SUBJECT: MCGUIRE NUCLEAR STATION, UNITS 1 AND 2 – STAFF ASSESSMENT OF RESPONSE TO 10 CFR 50.54(f) INFORMATION REQUEST – FLOOD-CAUSING MECHANISM REEVALUATION (CAC NOS. MF3623 AND MF3624)

STAFF ASSESSMENT BY THE OFFICE OF NUCLEAR REACTOR REGULATION

RELATED TO FLOODING HAZARD REEVALUATION REPORT

MCGUIRE NUCLEAR PLANT, UNITS 1 and 2

Figure 3.1-2. McGuire Nuclear Station Structures and Hydrologic Features (derived from USGS, 2016)

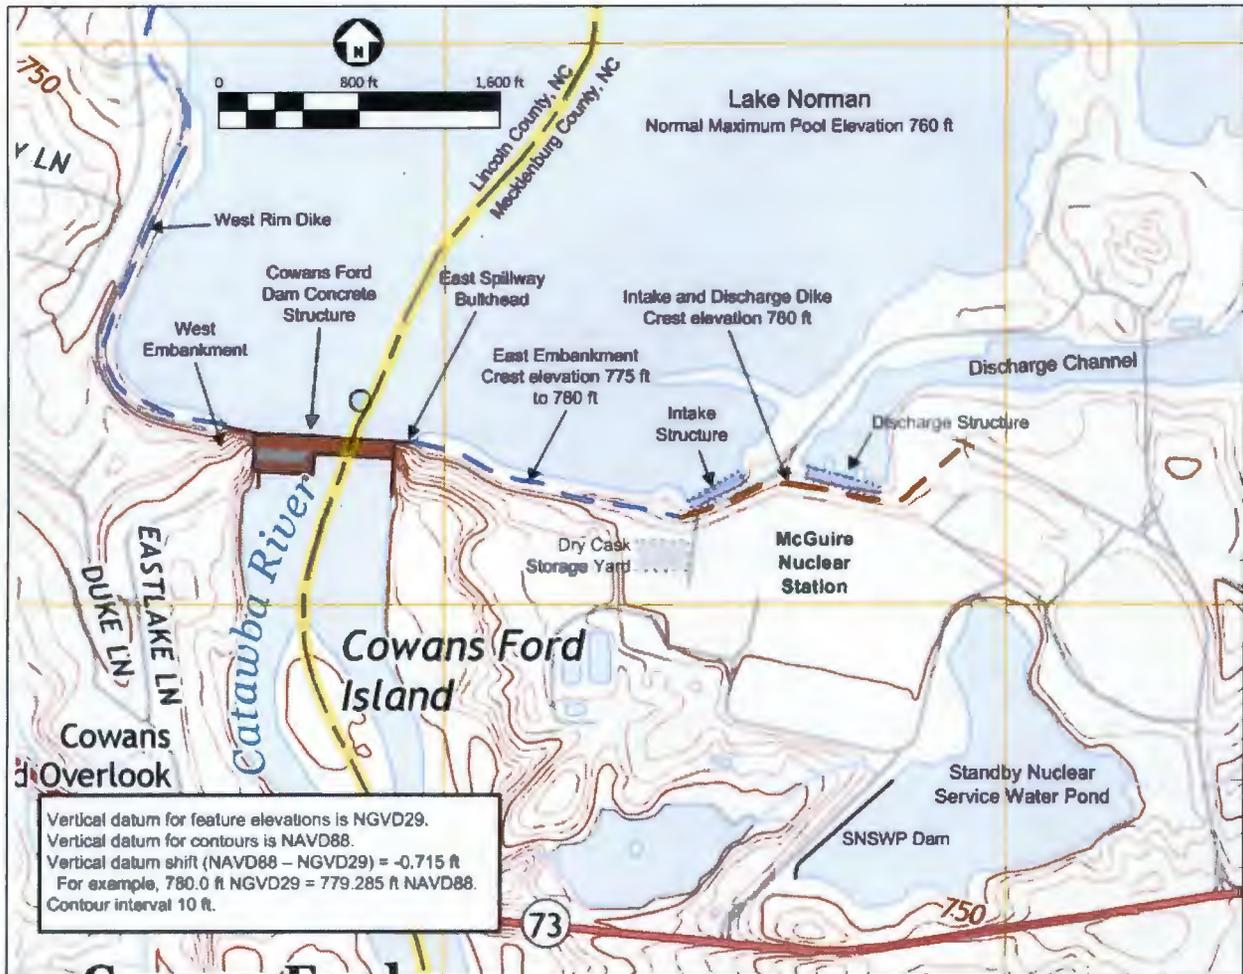
MSL northeast of the McGuire Yard. The intake and discharge dike has a crest elevation of 780 ft (237.74m) MSL, and protects the McGuire yard from flooding from the north. The intake structure, which takes cooling water from Lake Norman, is adjacent to the intake and discharge dike. The discharge structure is located immediately east of the intake structure, and discharges water back to Lake Norman through the discharge channel (see Figure 3.1-2).

The licensee determined the 2-D model's extent by security barriers, the intake and discharge dike, and ground surface sloped away from the site (see Figure 3.1-2) (Duke, 2015). On the north and northwest sides of the site, the intake and discharge dike serves as the boundary. On the east and northeast sides of the site, the security barriers serve as the model boundary. On the south and west sides of the site, the boundary of the model corresponds to where the ground surfaces sloped away from the site (Duke, 2015).

The NRC staff reviewed and agrees with the assumptions and inputs, and with the boundaries as described by the licensee in the hydraulic model. The NRC staff also concludes that the maximum flood levels identified at or near the safety-related structures are conservative and acceptable for the focused evaluation.
